Report of the Independent Review Panel

Design Document for Expansion of Yankee Doodle Tailings Impoundment

Montana Resources, LLP  
Butte Montana

November 20 2017

Figure 1- Core exemplifying the complex nature of the YDTI embankments

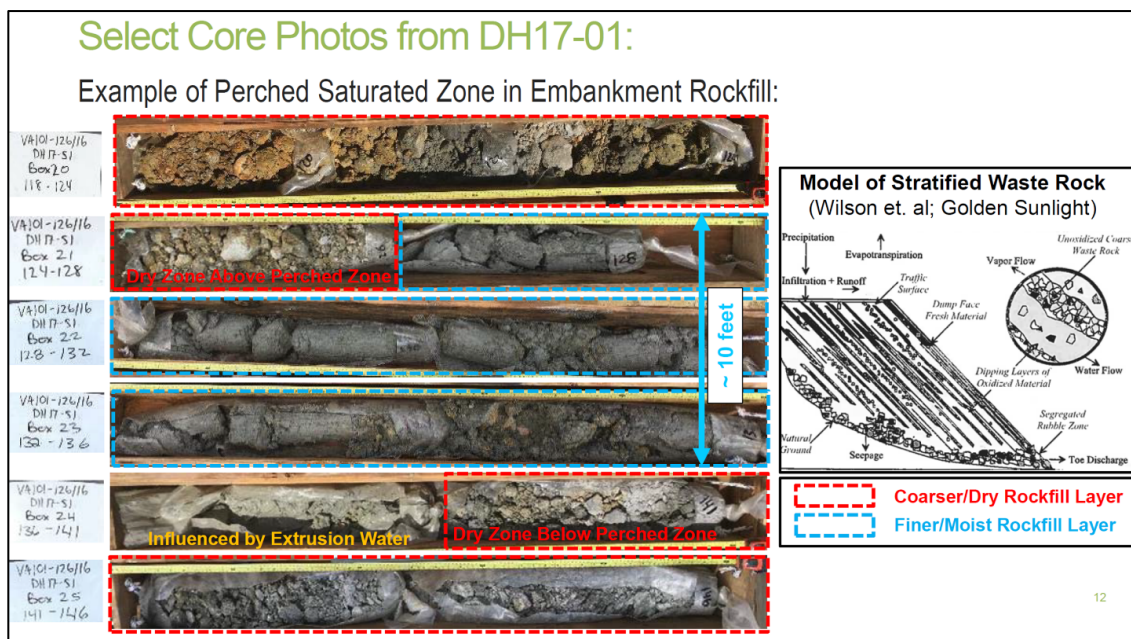
KP provided preliminary data to the Panel from one of the sonic drill holes completed in 2017 (DH17-01 near the toe of the embankment along Section 0+00) and the referenced drawing was used to illustrate the varied, angular fabric of the structure (Figure 1). Based on their review of the historical construction sequences, KP interpreted the complex orientations of the layers in the embankments as being further amplified by the construction of multiple embankments with upstream and downstream sloping layers and basal layers of cobbles and boulders. The 2017 site investigation program incorporated downhole geophysical testing (P-wave and S-wave suspension logging). Future site investigation programs may incorporate this technique provided the 2017 data is valuable. Complete results from the 2017 site investigation program are anticipated to be available before the end of the year. MR plans to install another set of boreholes on a second transect through the East-West Embankment in 2018.

Figure 2 - Photo of cut in the nearby Great Northern Dump showing angular orientation of rockfill layers

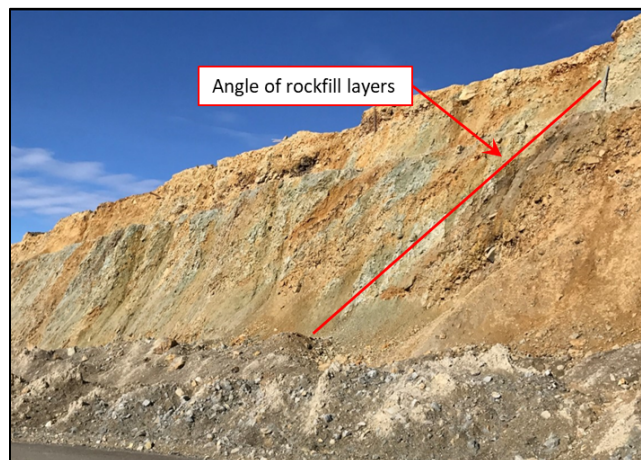
- It is the Panel's opinion that the embankment composition pattern makes it unlikely that large-scale, continuous horizontal layers of saturated fine-grained materials exist within the embankments, at elevations above the basal water table.

Figure 3 - East-West Embankment at Section 8+00W

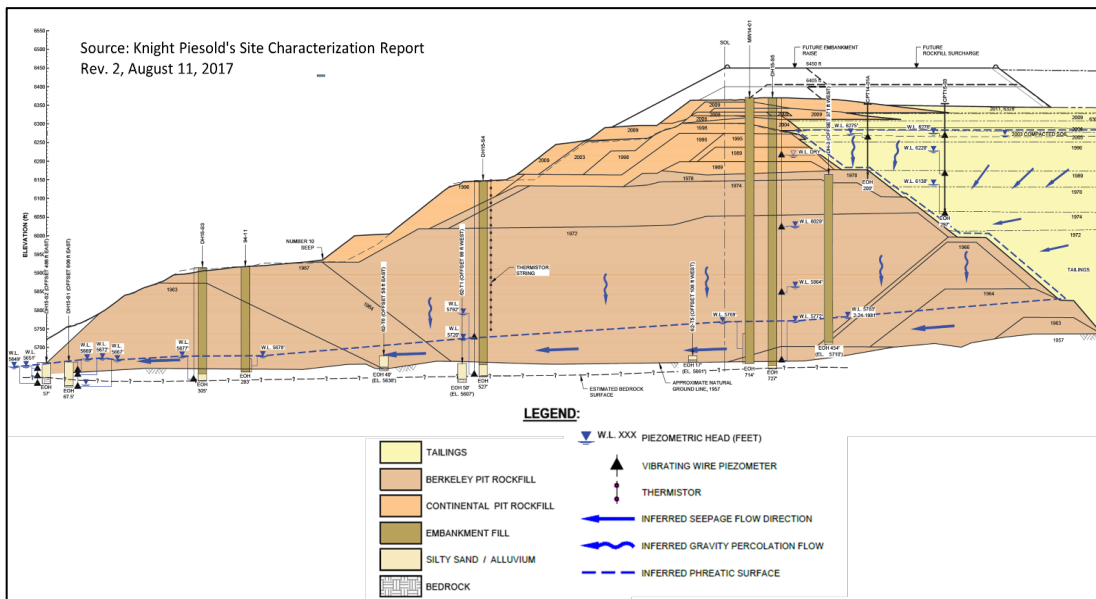
- Based on site observations and review of the drill logs, the Panel agrees with KP's characterization of the East-West Embankment as an obliquely stratified heterogeneous rockfill embankment. A photo presented in Section 4.2 of the Site Characterization Report (see Figure 2 below) shows a cut into a nearby rockfill dump constructed at a similar time with similar methods as the YDTI embankments. The photo shows the angular fabric of the structure. The complex orientations of the layers was further amplified by the construction of multiple embankments with upstream and downstream sloping layers as indicated in Section 8+00W included in KP's August 2017 Site Characterization Report (see Figure 3 below).

- Based on review of piezometric data and drill logs, the Panel agrees with KP's interpretation of the East-West Embankment as being "relatively unsaturated" with several isolated perched saturated zones with downward gradients and a basal saturated zone in the bottom 50 to 120 feet of the structure, as shown in Figure 3. The Panel accepts as reasonable the KP interpretation that Seep 10 is due to the presence flow along an old haul road or pipe ramp that was incorporated in the downstream shell, and is therefore not an indicator of a large zone of saturation located well above the elevation of the basal saturated zone.

Figure 4 - Stability model used in ARCO’s screening level analyses

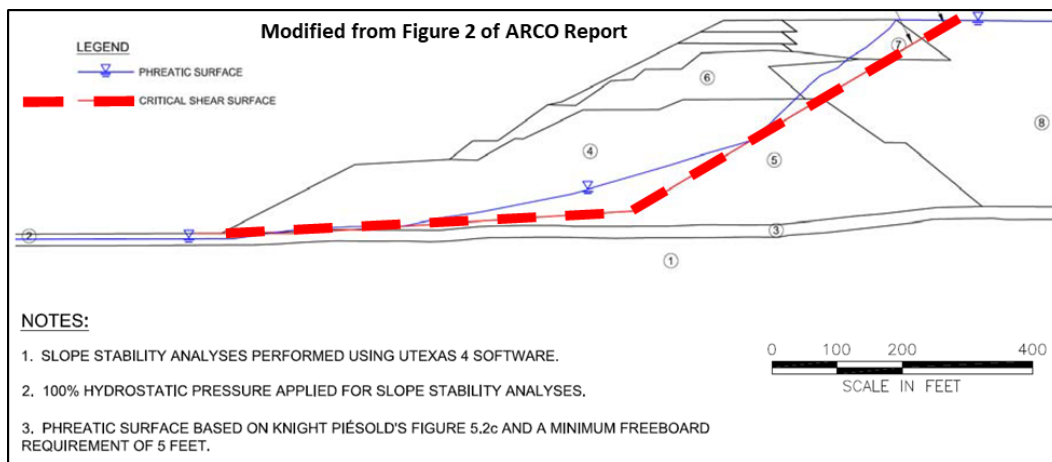
ARCO performed “screening-level” analyses of stability based on information from KP’s stability report issued in November 2016 (Rev. 0). The model that was used is shown in Figure 4 below.

These screening level analyses resulted in calculated Factors of Safety (FoS) ranging from 0.89 to 1.01, thereby not meeting required stability criteria. It is pointed out here that these analyses were conducted prior to the time that ARCO had additional information from KP that resulted in ARCO commenting that “the saturated zone

- It is the Panel’s opinion that the stability analyses performed by KP as described in their August 15, 2017 Stability Assessment Report (Rev 2) are representative of the conditions as they are presently understood to exist at the YDTI facility and for the planned raise to El. 6450 m. Accordingly, it is believed that the MCA Factor of Safety requirements have been met or exceeded.
- It is anticipated that with the conversion to the multi-spigot tailings distribution system, there will be a reduced infiltration rate into the upper part of the upstream face of the East-West embankment, and a greater component of flow entering the embankment face at depth.
- The Panel agrees with KP’s concept regarding the use of excess rockfill from the Continental Pit to further minimize risk of unstable conditions.
